SAB-EEC-87-015

# REVIEW OF TECHNICAL DOCUMENTS

# SUPPORTING PROPOSED REVISIONS TO EPA REGULATIONS FOR THE DISPOSAL/REUSE OF SEWAGE SLUDGE UNDER SECTION 405(d) OF THE CLEAN WATER ACT

THE ENVIRONMENTAL ENGINEERING COMMITTEE

Diagram 2: Typical exposure distribution profile with selection of increasingly conservative MEU. (Shaded area represents relative fraction below MEU).

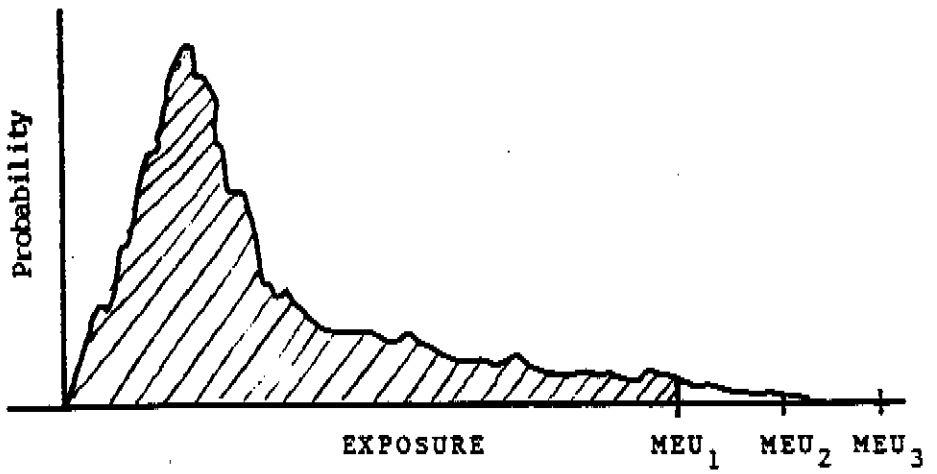
A possible exposure distribution is illustrated in Diagram 2. To provide a framework for discussion, three general shapes for the exposure distribution are proposed (Diagram 3). Type A depicts a situation in which almost all the population receives a zero or nondetectable exposure, represented by a probability mass at zero. A small subpopulation is exposed with the indicated distribution. Type B represents a situation in which all members of the population are exposed, but the distribution is highly skewed, so that most receive small exposures while a few receive very high exposures. Type C depicts the case where exposures are more broadly and evenly spread throughout the population.

The use of this framework for classification of the different exposure pathways and their associated MEIs can help provide better characterization and comparison of the different disposal options. For example, the following classifications are suggested:

Diagram 1: Representative exposure distribution profiles.

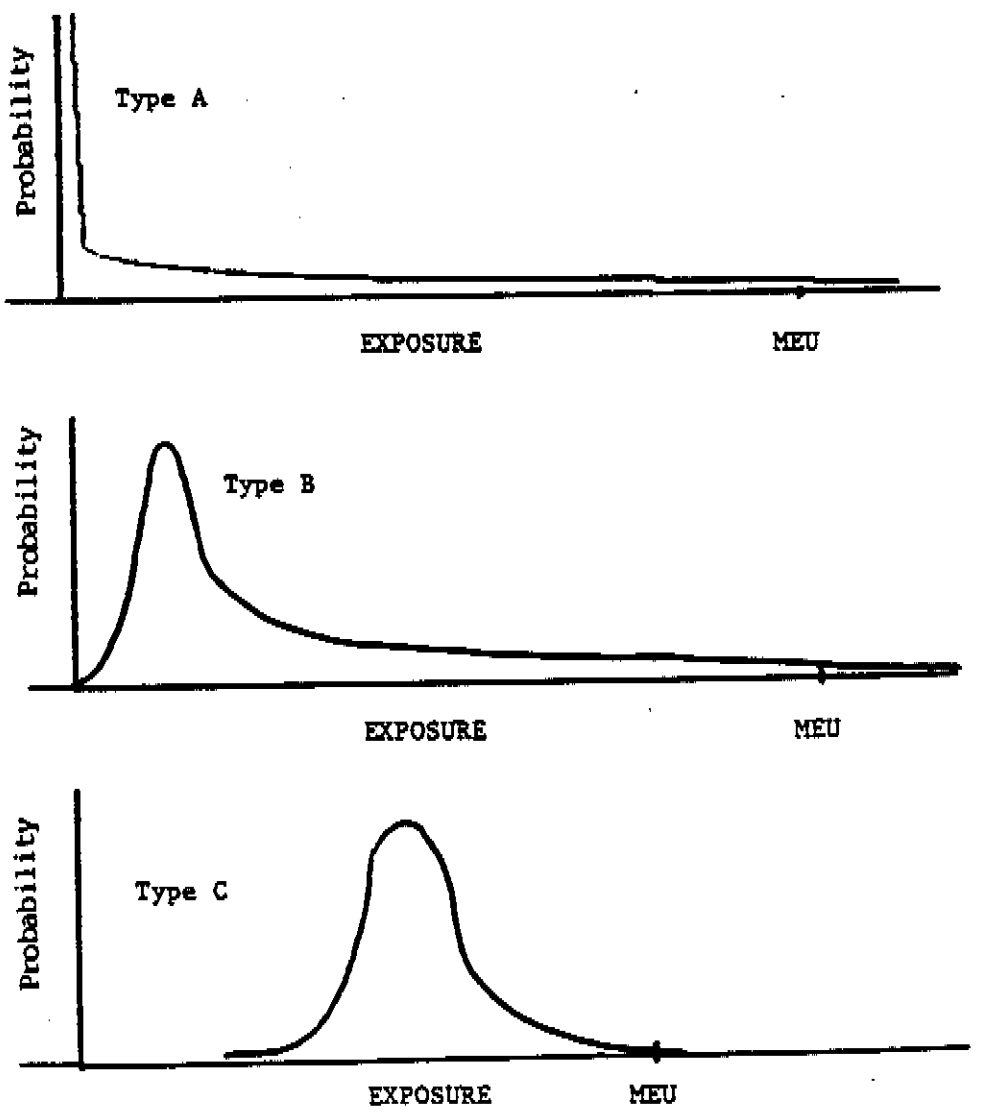
1. Exposure by consumption of fish caught near the ocean disposal site appears to follow a Type A distribution;

2. Exposure to residents breathing in the vicinity of a sludge incinerator is most likely Type B;

3. Exposure through the food supply from sludge applied to cropland is likely to be Type C.
